We have reviewed the closure plan submitted on March 17, 1982, for closure of the surface impoundment at the Springfield, Missouri facility. Closure of interim status hazardous waste management facilities is to be conducted in accordance with requirements contained in the July 1, 1981, 40 Code of Federal Regulations (CFR), Part 265, Subpart G, Closure and Post-Closure. Review of the closure plan resulted in the following comments:

March 17, 1982

Please find enclosed our revised closure plan which was originally submitted on March 17, 1982 for closure of our surface impoundment in Springfield, Missouri. This revised plan reflects the necessary steps taken to meet the requirements set forth in the March, 1982 Eminent Hazard Status issued to Advanced Circuitry by the Missouri Department of Natural Resources. It is also felt that our closure plan meets the requirements contained in the July 1, 1981 40 Code of Regulations Part 265, Subpart G, Closure and Post Closure.

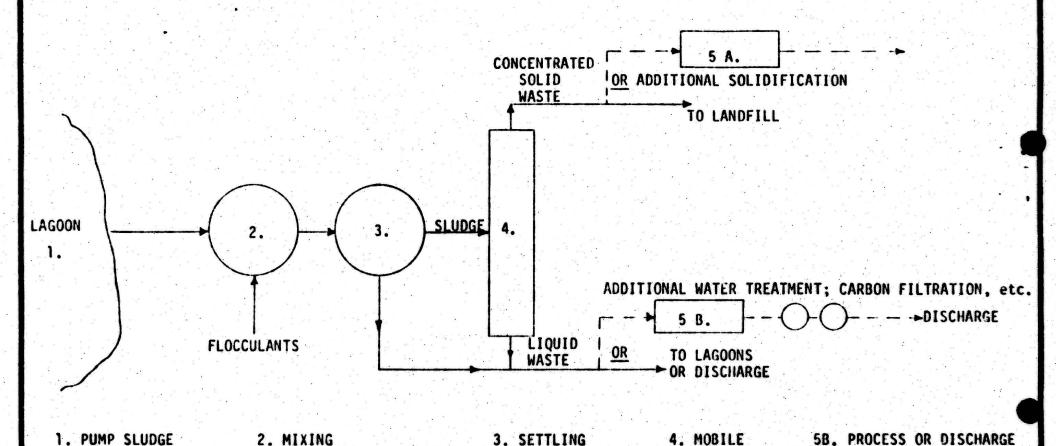
- 3.1 Mobilize equipment to customer's site.
- 3.2 Set up equipment according to previous planning. The following process steps outlined in Figure 1 are included as required.
